ZONING BOARD OF APPEALS

WEDNESDAY August 7, 2024, @ 6:30 P.M.

a. Planning Department report

DRAWING:

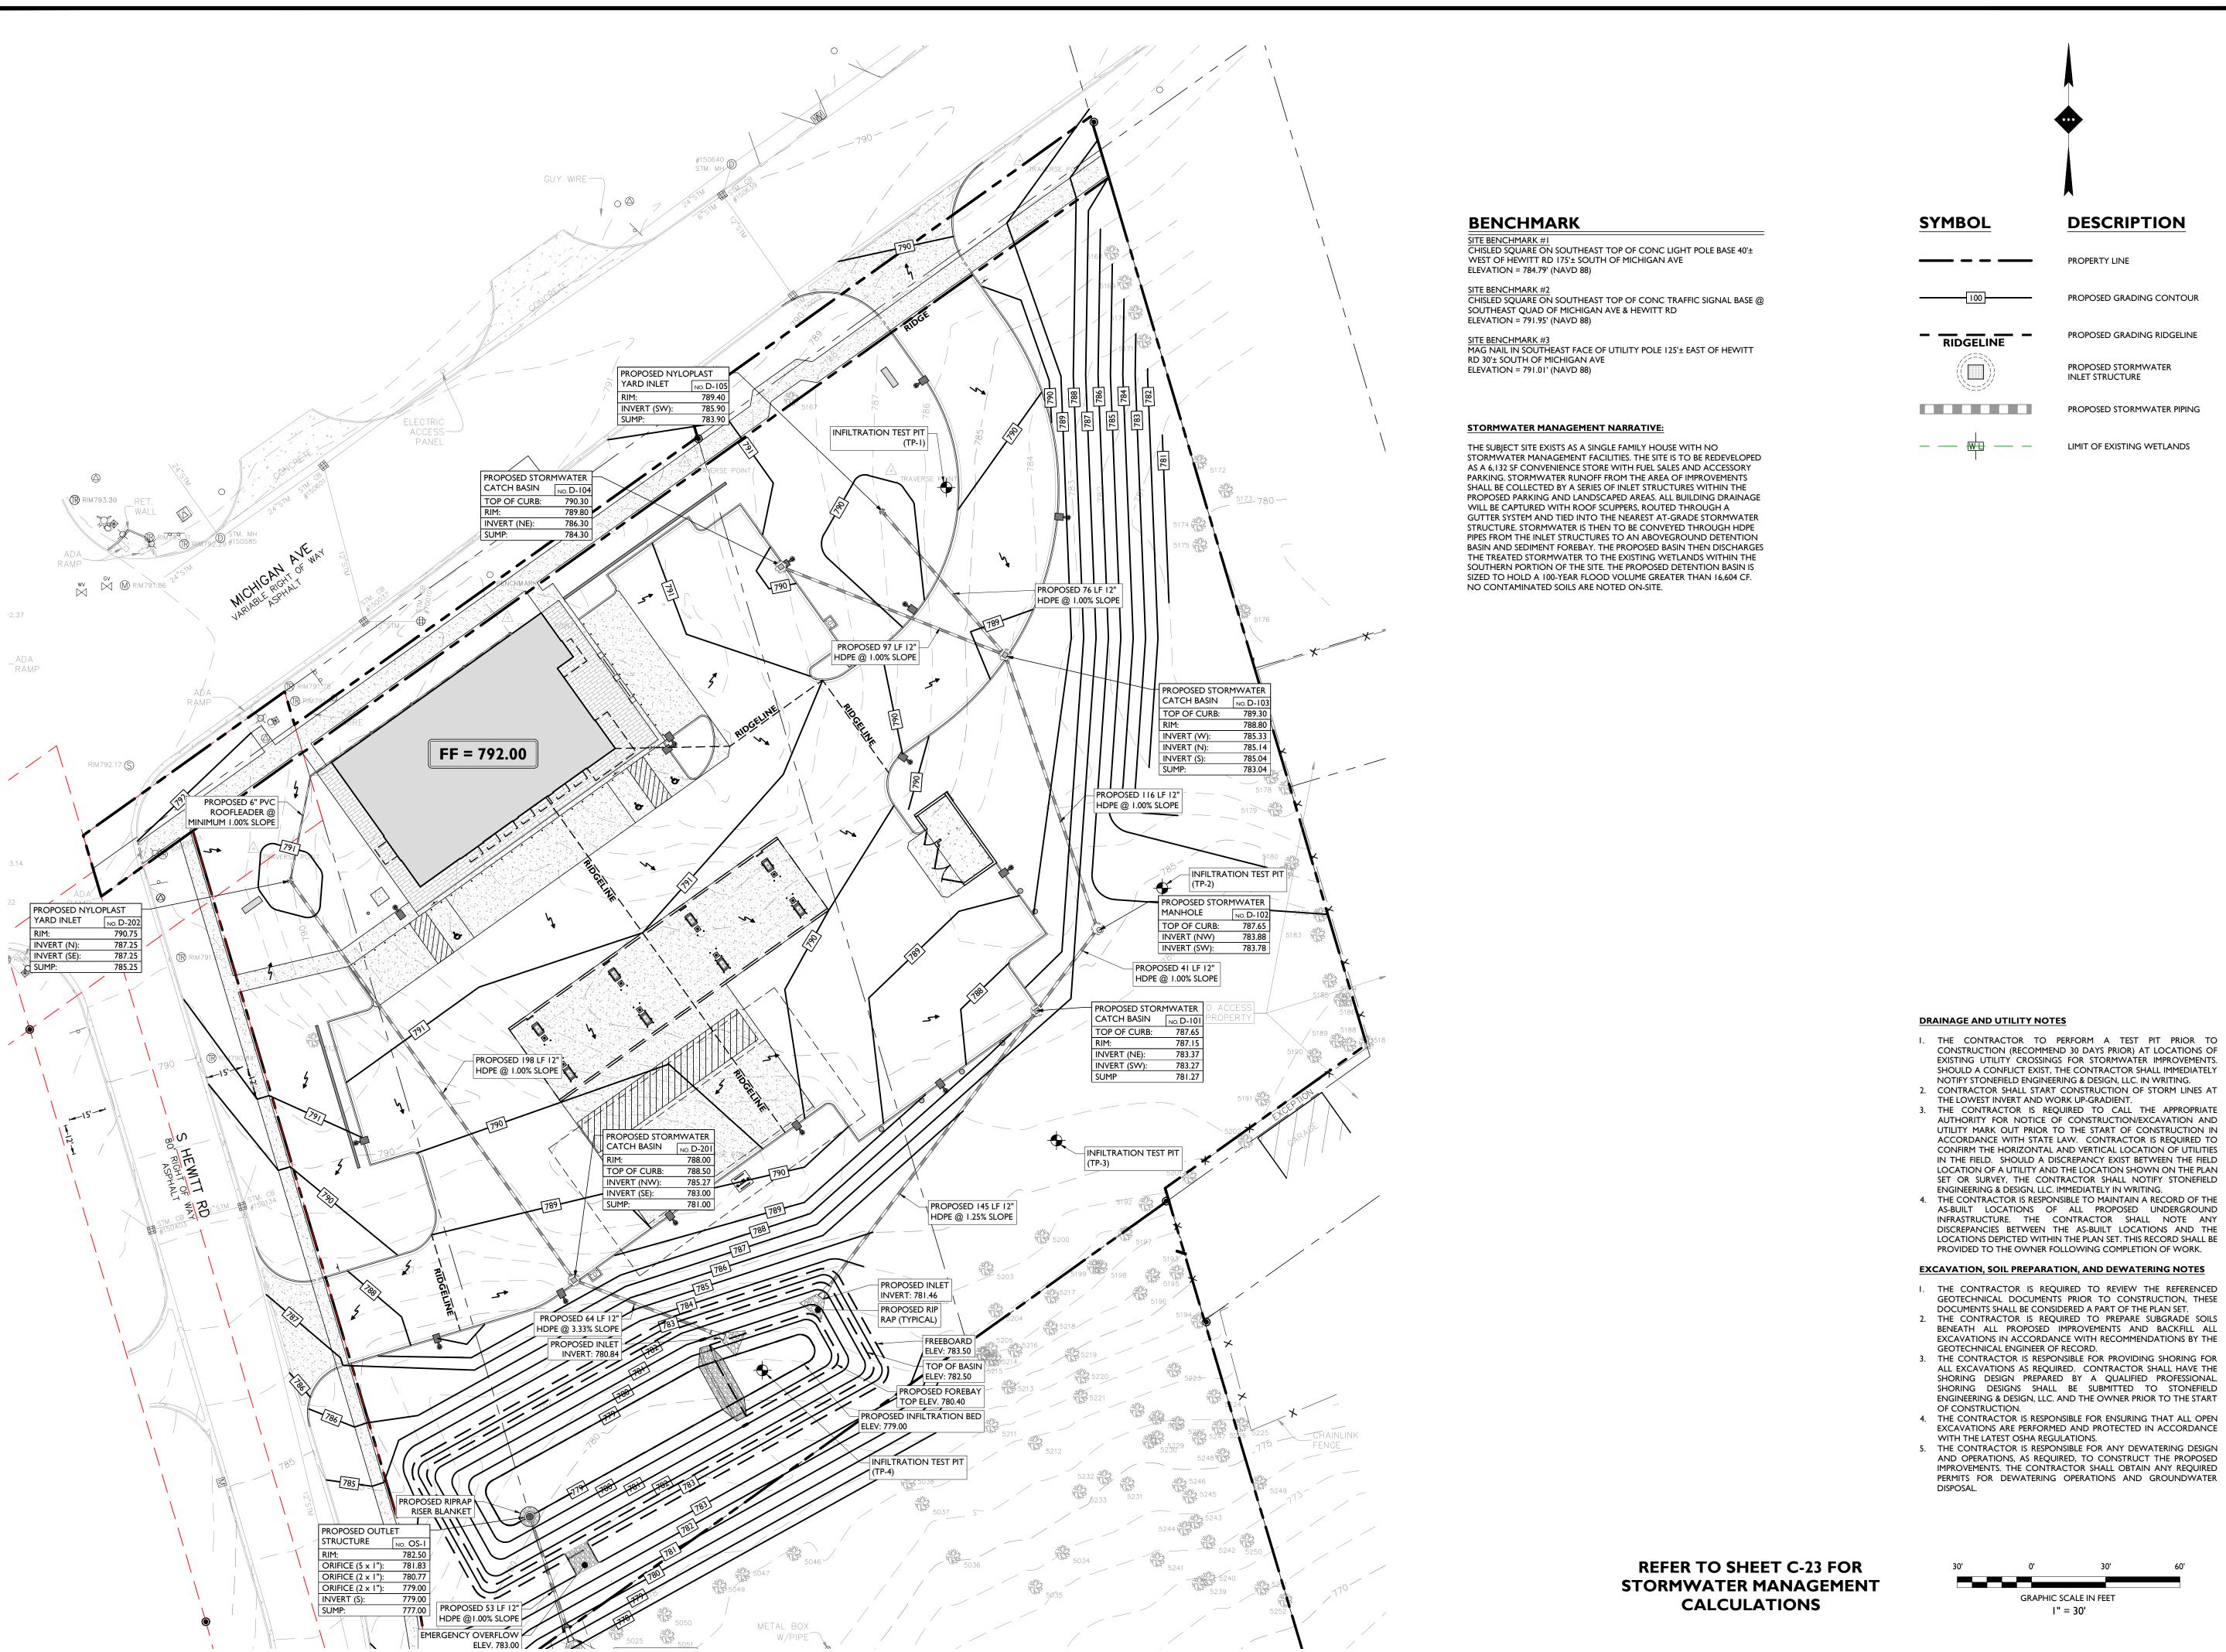
Building Location: The site is occupied by a road easement in the northwest corner, as shown on Sheet C-6. The ordinance requires that the building be placed at the 10-foot build-to-line, which is the line 10-feet from the front property line along a street. Because of this road easement, the building cannot be located 10-feet from the S. Hewitt Rd. property line. Therefore, special circumstances exist on this property that make compliance with the ordinance for building location impossible.

The applicant has not provided any floor plans to show how the interior of the building coordinates with the location of doors and windows. Floor plans should be provided with the variance request to allow the Zoning Board of Appeals to confirm windows/doors would interfere with these facilities.

However, regarding the transparency variance requests, the applicant should provide/respond to the following:

- 1) Floor plans should be provided with the variance request.
- 2) <u>W. Michigan Ave. Transparency Variance</u>. The applicant should respond to the following, and offer other options to increase the transparency on the W. Michigan Ave. façade:

- c. Has the applicant considered allowing customers to view the activity in the food preparation area?
 - d. Would it be possible to add a pedestrian door on the W. Michigan Ave. side of the building?

- 3) <u>S. Hewitt St. Transparency Variance</u>. ZBA and applicant to discuss flipping the orientation of the building, and locating the patio (with the associated window/door configuration) on the west side of the building, facing S. Hewitt. Benefits this could provide include:
